Agenda Item # 5

Subject: Resolution No. 2020-32: Appeal of a Design Review Application – 126 Mount Hamilton Avenue

Subject: Appeal of a Design Review Approval for a Two-Story Residence at 126 Mount Hamilton Avenue

Front Elevation / October 2019

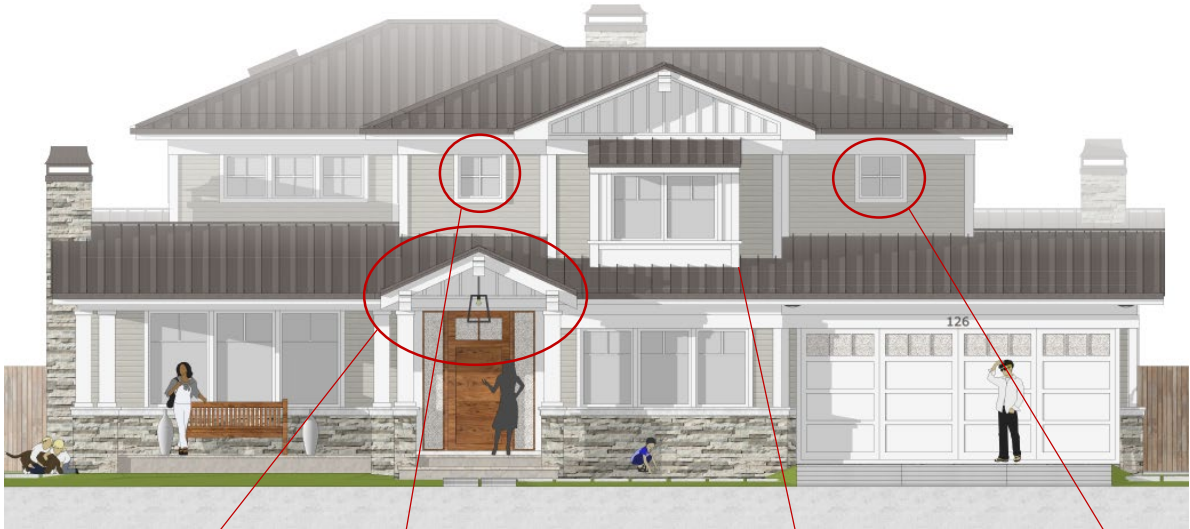
The decrease in the second story massing is further shown in the above front roof perspective.

Second Story Floor Plan / October 2019

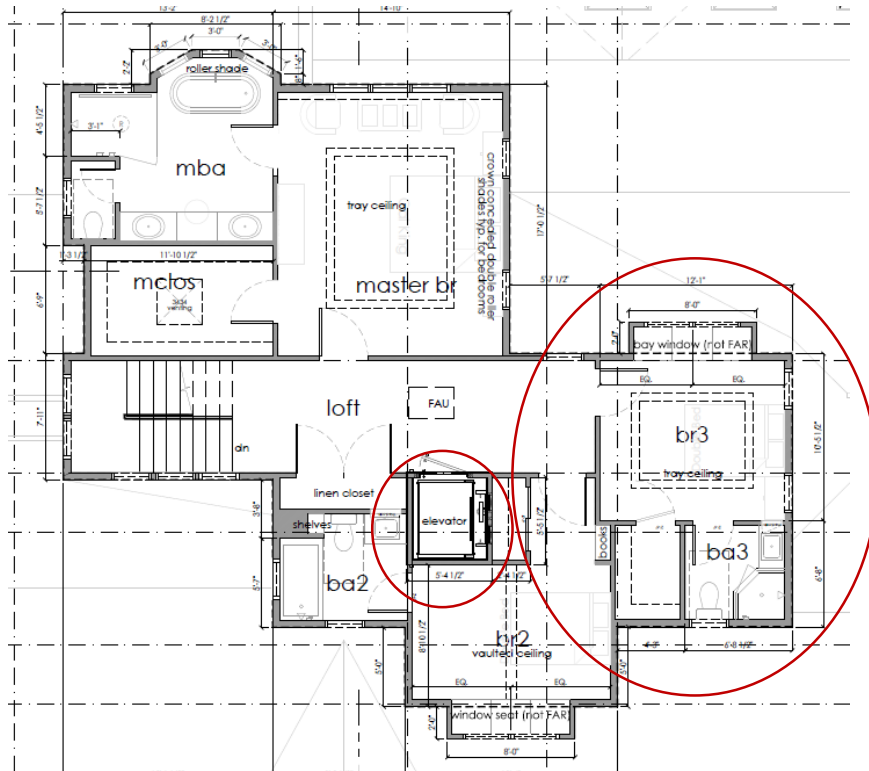
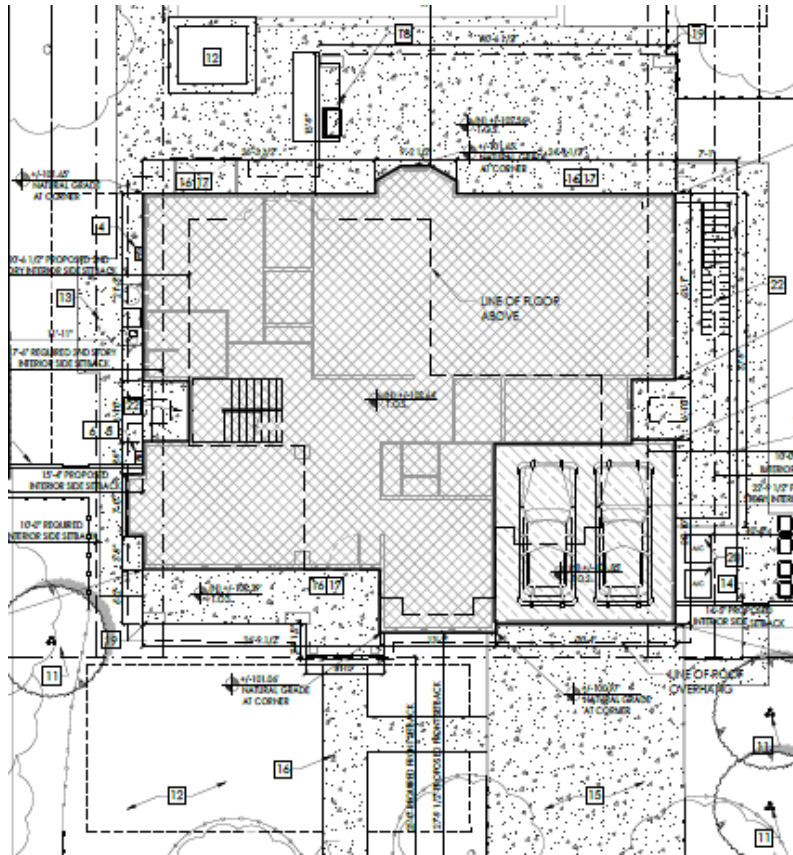
Modification: Bedroom #2 was pushed back 3 feet to reduce visual mass; Bedroom #3 was changed to be rear facing to reduce the amount of front-facing glazing; an elevator was added to service all levels.

West Elevation (Right Side) / October 2019

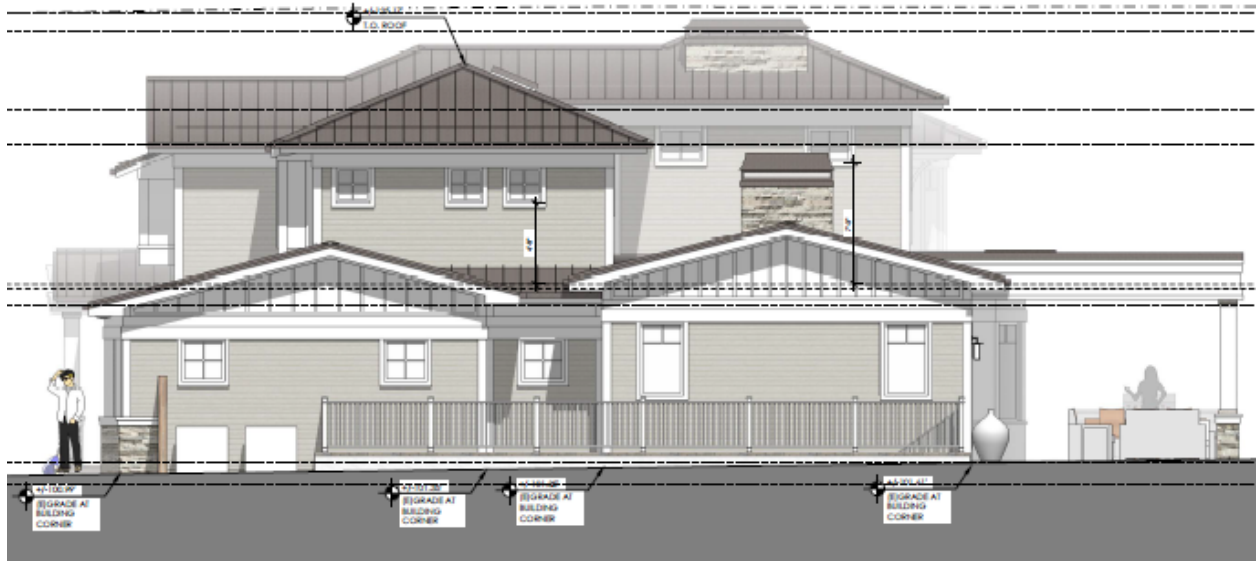
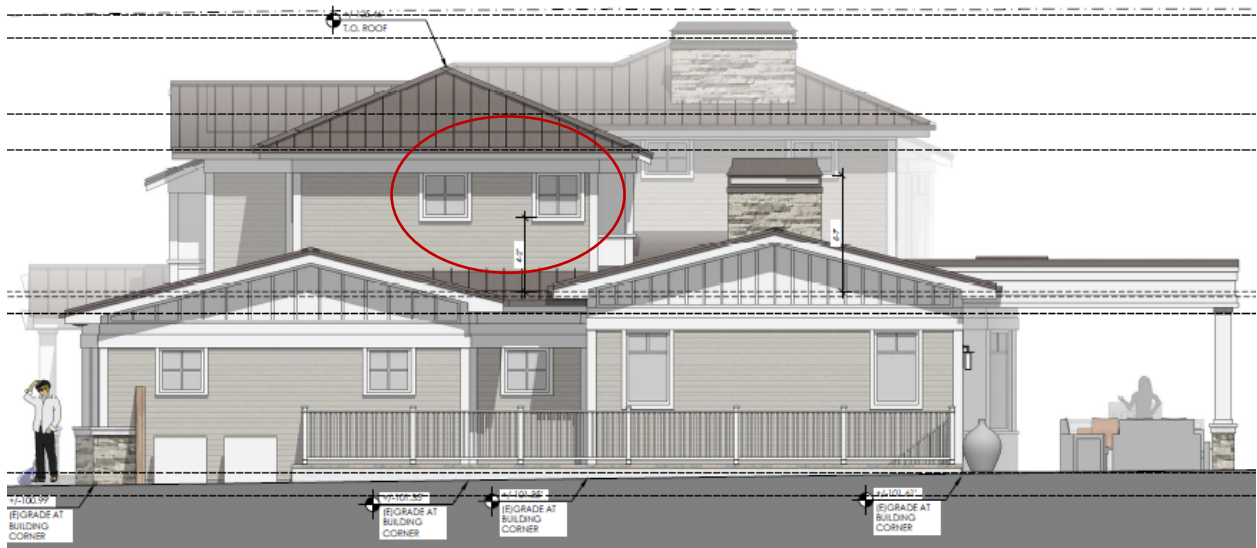
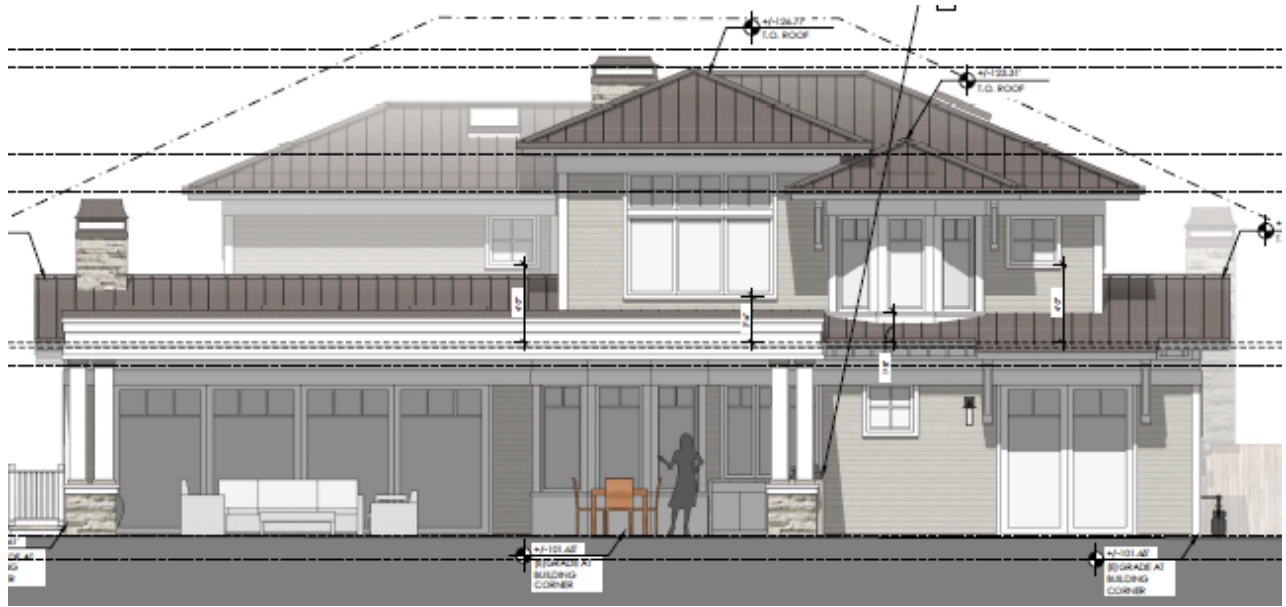
Modification: The number of windows on the West Elevation was reduced; the second story side setback was increased to 23.8 feet, where 17.5 feet is required in a R1-10 District.

Rear Elevation / May 2020

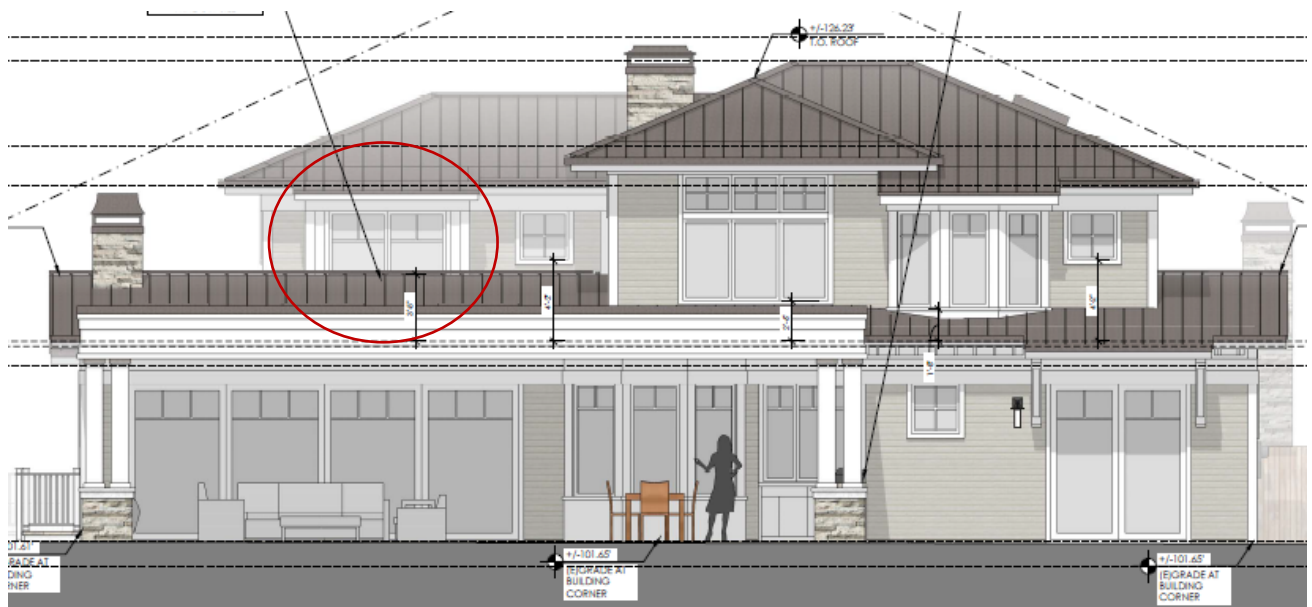
Modification: The bay window in Bedroom #3 was moved to the rear elevation; however, the project proposed an increased rear yard setback of approximately 52.4 feet, where a setback of 25 feet is required in a R1-10 District.

East Elevation (Left Side) / May 2020

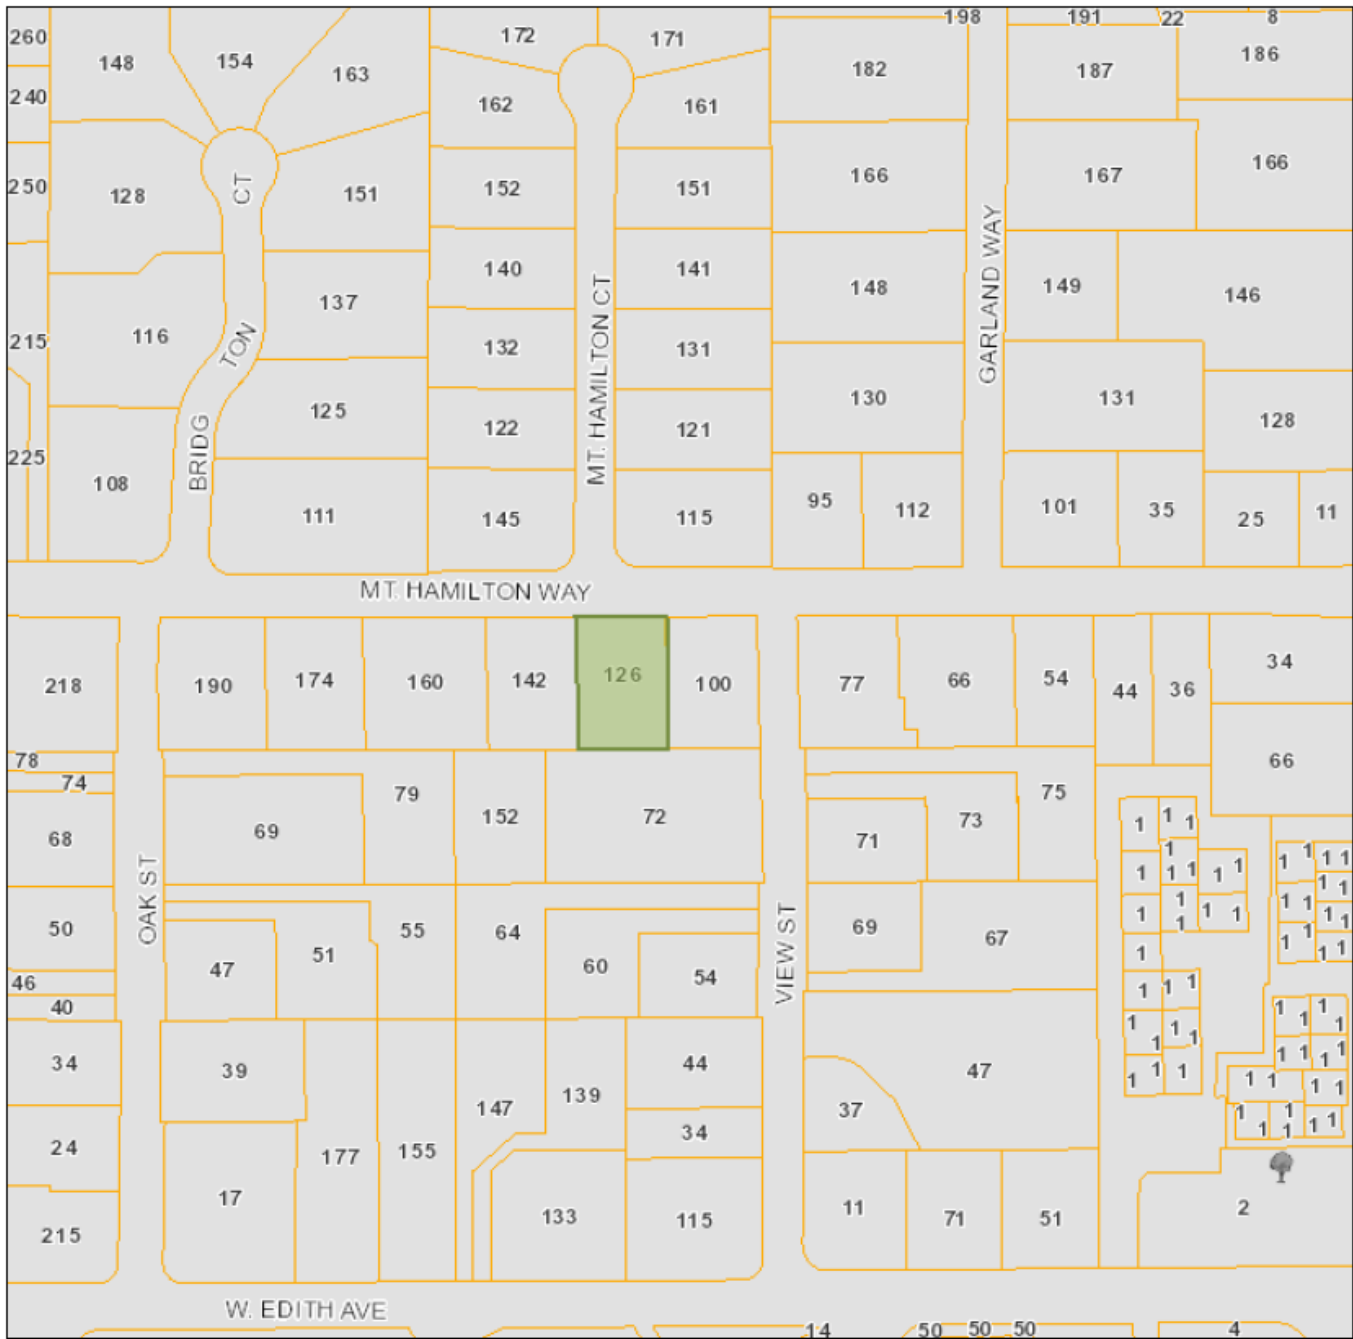
On the East Elevation, there are no major changes on second story in regards to massing and privacy.
